ADDENDUM TO DESIGN AND ACCESS STATEMENT

MINOR PLANNING AMENDMENTS TO APPROVED CONSENT

FULL RENOVATION OF EXISTING No 11 TERRACE HOUSES

St Bees, 1-11 Lonsdale Terrace, Parish Council, Cumbria

Elevation 6 (house 6 side elevation)
1 : 100

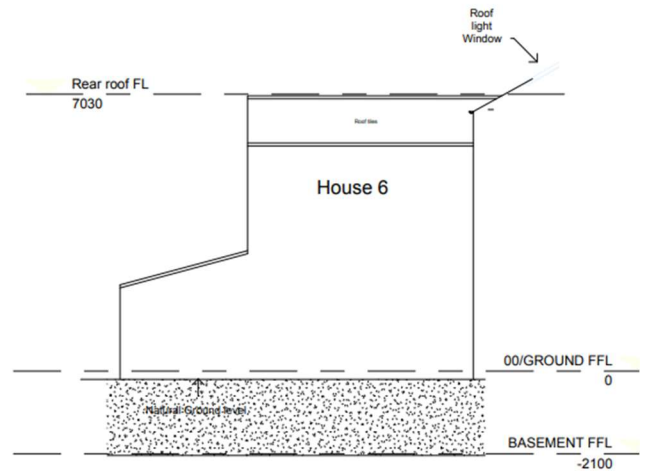
From the rear of house, no 6, a modern dry verge has been applied to the verge of the roof which is completely out of character. See below.

The roof is covered with a modern cement tile with a dry verge detail.

The current roof pitch is 15 degrees.

The proposal is to replace the rotten joists with new joists as recommended by the structural engineer as 45 x 95 C16 GR multi rafters.

The proposal is then to replace the roof itself as the detail attached, with a roof tile that is warrantied at 15 degrees. The proposal is then to apply a traditional wet verge.

Elevation 7 (house 7 side elevation)

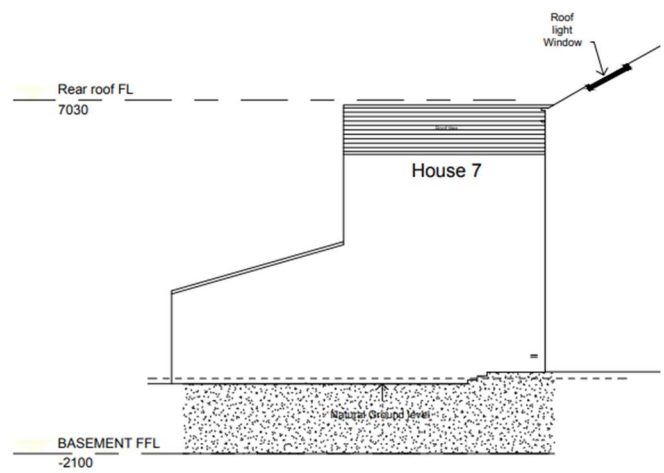
From the rear of house, no 7, a natural slate roof is the finish, however at 20 degrees – the absolute MINIMUM roof pitch, a slate roof is feasible, however the construction of this slate roof is not in accordance with the Building Regulations as the British Standards Ref: BS 5534:2014 which require slates to be a min size of 500 x 225 with a 135mm head lap, hence why the roof is leaking and again the joists suffering considerable damage.

For the reasons outlined above the proposal is then to replace the roof itself as the detail attached with a roof tile that is warranted at 20 degrees. The proposal is then to apply a traditional wet verge.

Elevation 8a (house 8 side elevation)
4 - 100

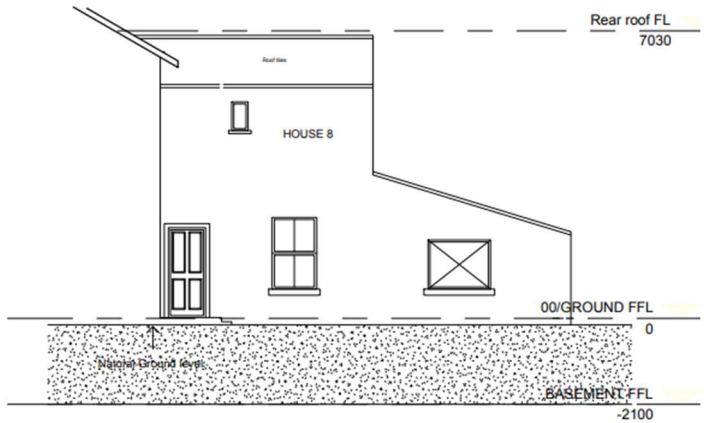
From the rear of house, no 8, a natural slate roof is the approved finish, at 20 degrees. This is the absolute MINIMUM roof pitch where a slate roof is feasible, as acknowledged by Building Regulations - British Standards Ref: BS 5534:2014. However, the roof itself does not accord with the Building Regulations, as the same British Standard require slates to then be a min size of 500 x 225 with a 135mm head lap. The low pitch along with the slate sizes, and the location of the buildings, is why the roof is leaking, leading to the considerable damage to the joists (as demonstrated by the photographs

For these reasons, the proposed amendment to the approved plans is to replace the roof itself as shown by the detail attached above, with a roof tile that is warranted at 20 degrees. The proposal is then to apply a traditional wet verge.

Elevation 9 (House 9 side elevation)

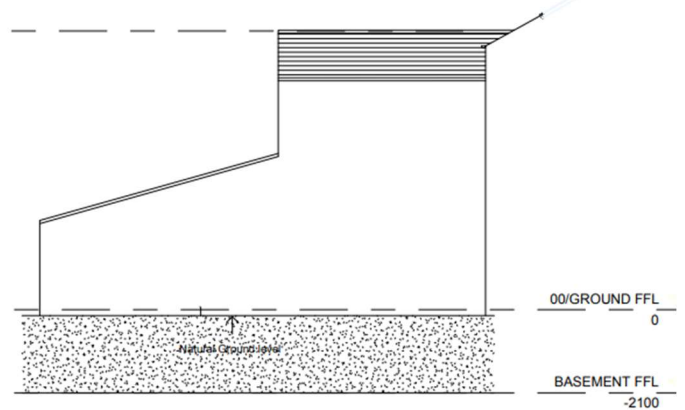
Now that they have been exposed, it is clear that the original joists have been replaced in most of the roof, unfortunately with new joists that are completely inadequate for the loads involved, and will require replacement with suitable sized joists.

It is also noted that this roof comprises a modern cement tile that is to be replaced with slate, so as to be consistent with the other rear extensions.

The pitch to this roof is also only 17 degrees, the low pitch not only been unsuitable for purpose but also a direct contributor to the damage identified. As this is a later extension, it is proposed to raise the pitch to the minimum required level, to prevent further issues. The change would not, however, be readily apparent, if at all.

For the reasons outlined above the proposal is then to replace the roof itself as the detail attached, with a roof tile that is warranted at 20 degrees. The proposal is then to apply a traditional wet verge.

Elevation 10 (House 10 side elevation)

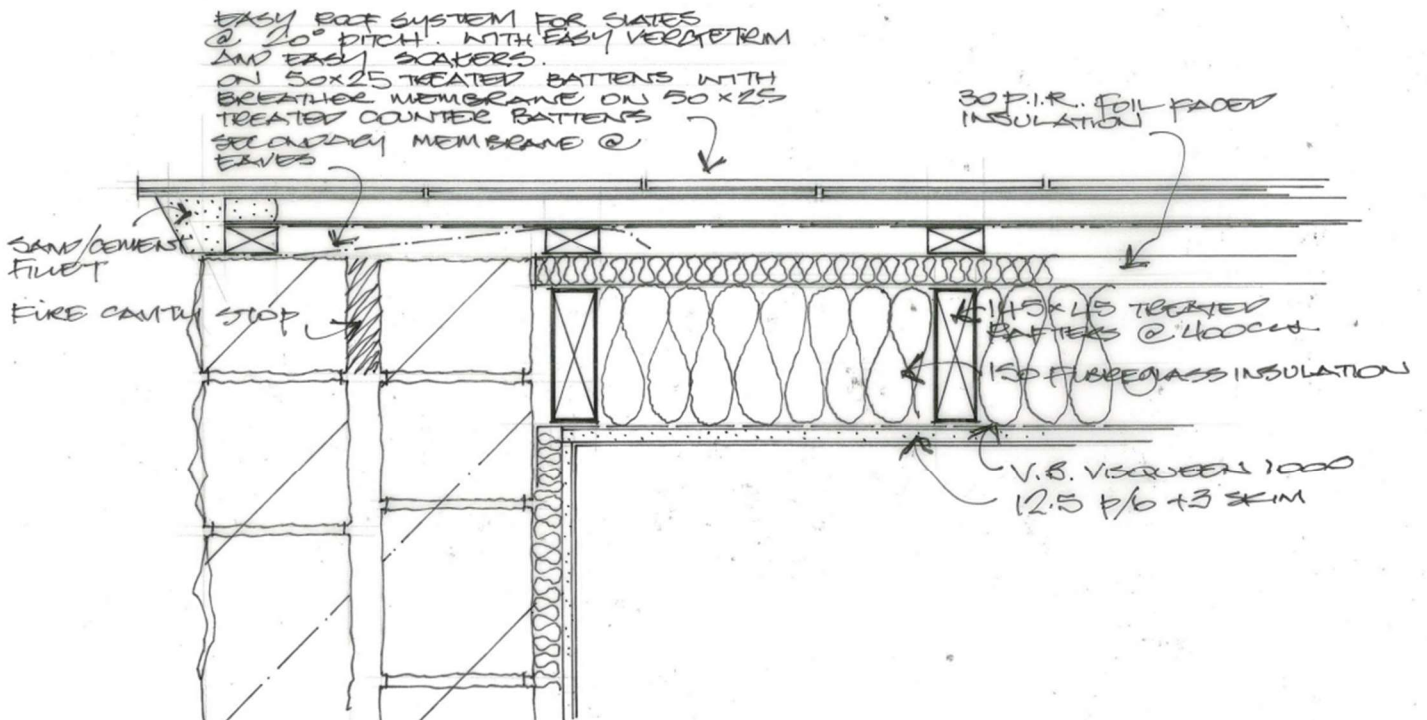
As for the other properties, once stripped out, the structure is exposed to reveal substandard rotten joists which have undergone inappropriate repairs. The joists are insufficient for the roof load and will require replacement.

From the rear of house, no 10, a natural slate roof is the finish, however at 20 degrees – the absolute MINIMUM roof pitch, a slate roof is feasible, however the construction of this slate roof is not in accordance with the Building Regulations as the British Standards Ref: BS 5534:2014 which require slates to be a min size of 500 x 225 with a 135mm head lap, hence why the roof is leaking and again the joists suffering considerable damage.

As identified previously, not only does the roof not conform with Building Regulations, but this has led to the issues identified, and the works required. In order to prevent them from reoccurring in the future, the proposal is to replace the roof itself as per our detail attached , with a roof tile that is warrantied at 20 degrees. The proposal is then to apply a traditional wet verge.

Above: Detail through verge

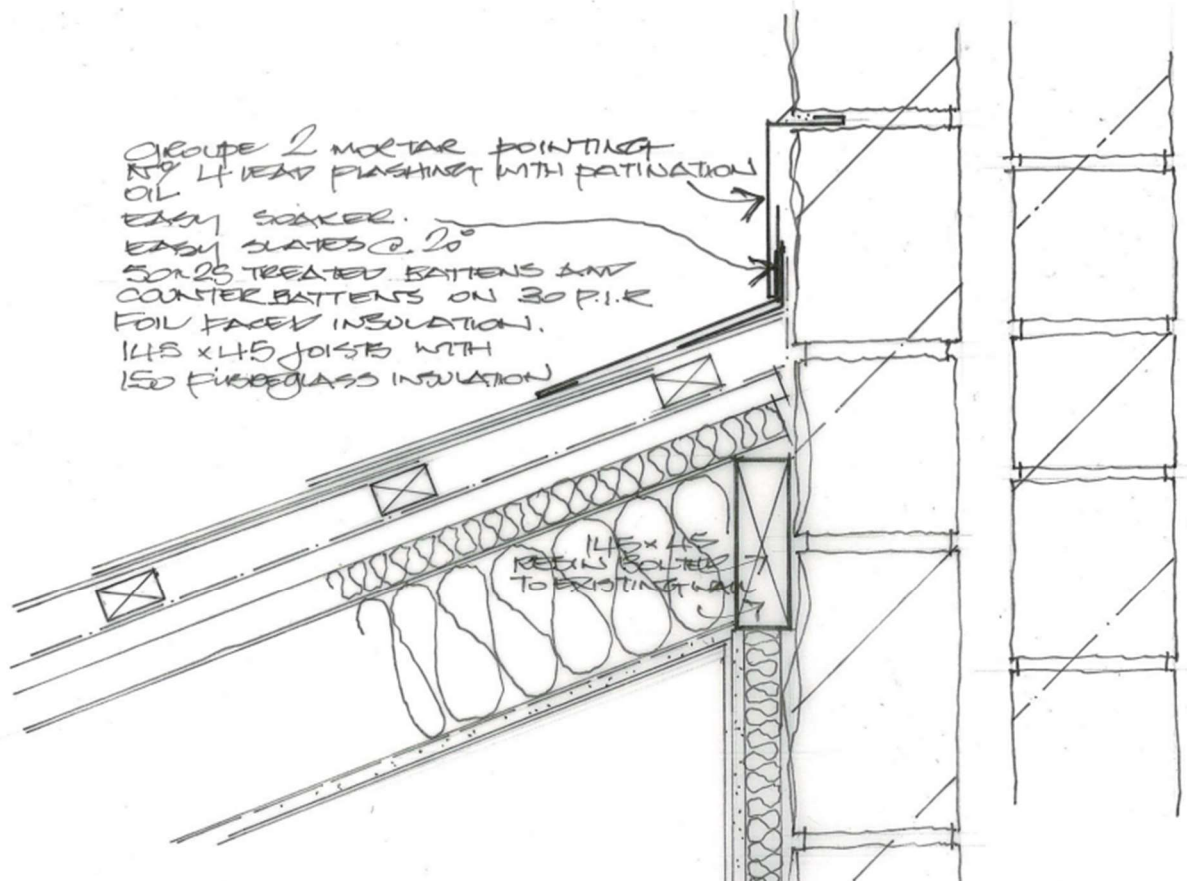
We propose a 'Britmet' tile which is a sustainable lightweight slate effect tile which can be installed down to a pitch of 12 degrees and manufactured from recycled materials. It is proposed to match the colour to the same colour of the existing slate roof of the existing houses, by using the colour 'slate'.

The approved layout plans with areas affected by the weak floor structure highlighted in blue.

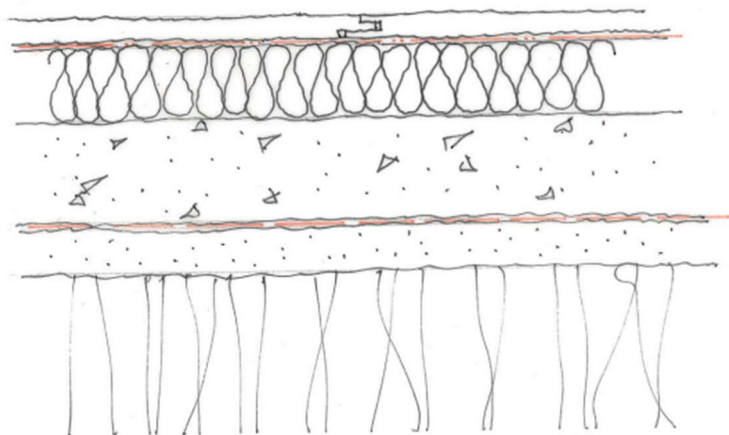
Once the existing tiled floor finishes were removed from the ground floor out rigger buildings, for properties 6,7, 8, 9 and 10 it was established that the floors were not only incredibly uneven but (following some very discrete investigation) only comprised 60mm of weak concrete laid on loose earth. Given that the extensions and concrete represent later additions, sensitive works to ensure their longevity are proposed below.

Obviously, this is not a suitable substrate for the loads which will be applied to a domestic floor, and the floor is likely to subside and break up. Our proposal is to sensitively remove the existing slabs and provide and install new floors to these areas as specified in the sketch (right).

*20 SKEEP BOARD SEAMED JOINTS.
ON 100g. VISQUEEN VAPOR BARRIER
TO P.I.R. BOARDED FLOOR FACED.
100 CONC. SLAB.
1200g. HIGH PERFORMANCE D.P.M.
ED SAND
HARDWARE*

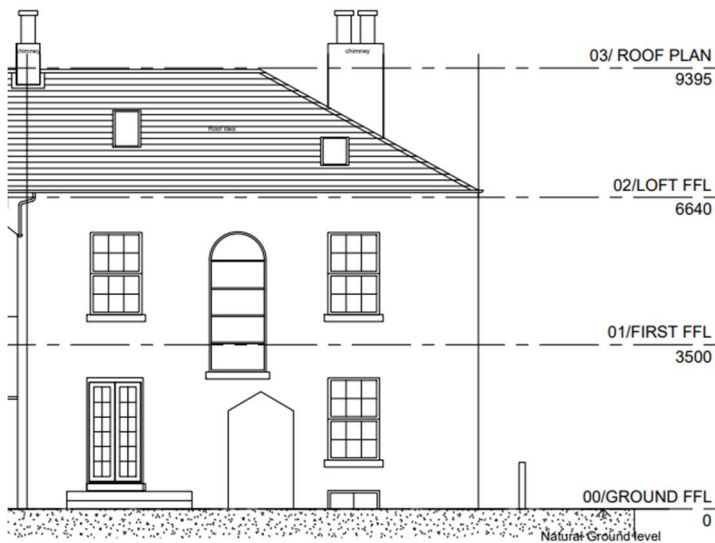
Permission was originally granted for new bi-fold doors to the rear of no 11, by replacing the original window and widening the opening, to create a new access to the garden at the rear. It is now proposed to retain the existing opening and introduce a pair of French doors instead. By doing this we retain more of the original historic fabric and more of the character of the property.

New proposed French doors in lieu of bifold doors. Instead of aluminium, these proposed doors would be heritage style double glazed painted timber to match the existing windows.

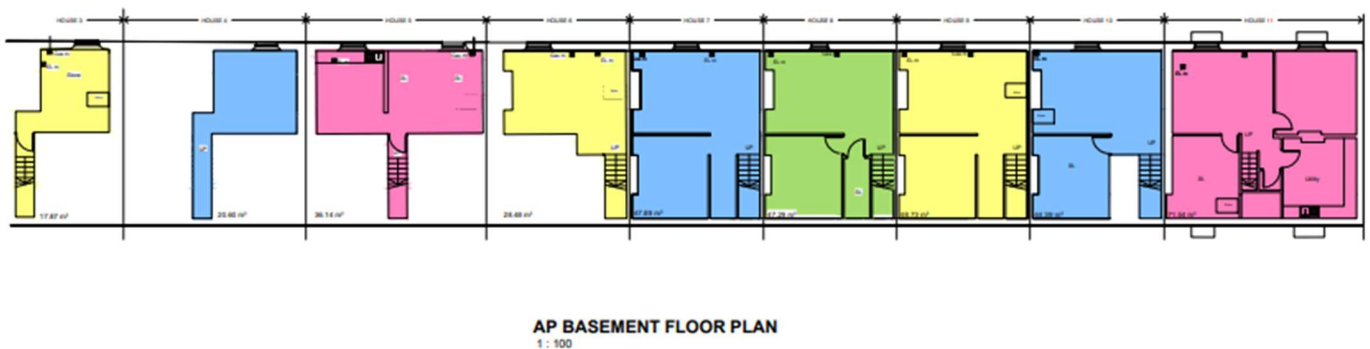
It is proposed to retain the 'blind' window to the rear, on the first floor, but instead of painting on a window – it is proposed to simply paint over it – a feature that is utilised on houses 1,4 and 5

It is also proposed to wall up the basement window and form a 'blind' window detail, as this window will be covered by patio steps from the kitchen into the garden. The window is not required internally as it is a store. The walls will be made good.

The approved scheme

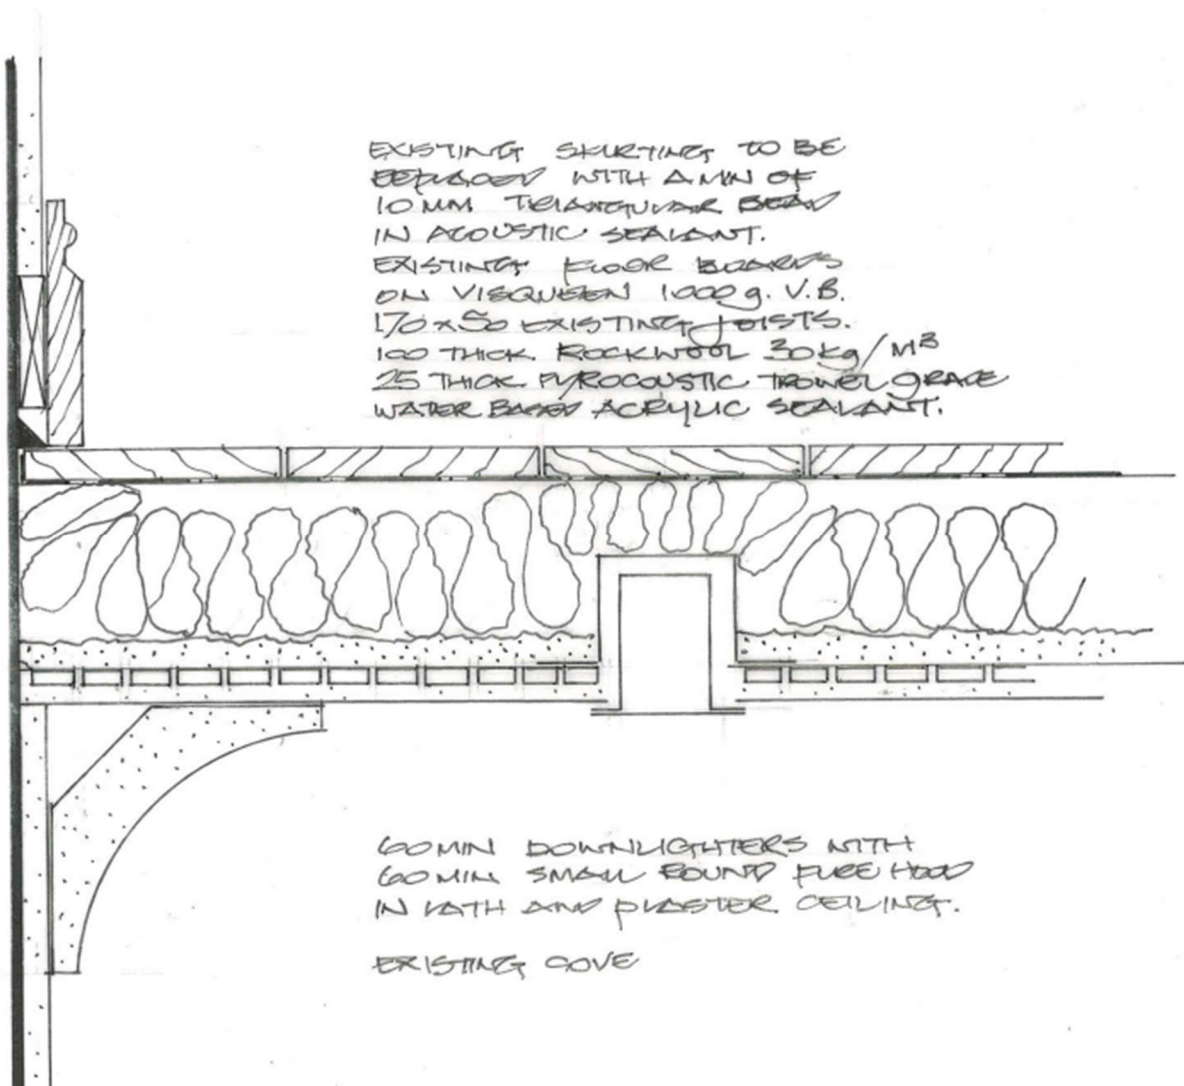
Further to detailed design of the kitchens and utility rooms, the configuration has been amended slightly from the originally approved plans. The new plans make better use of the space and also reduce the impact on the heritage asset. A full-size drawing with the revised layouts accompanies this application.

It was also assumed that house no 10 would have a chimney breast as houses 6-9, however once the false wall was removed here was no chimney breast, so the updated plans also reflect this.
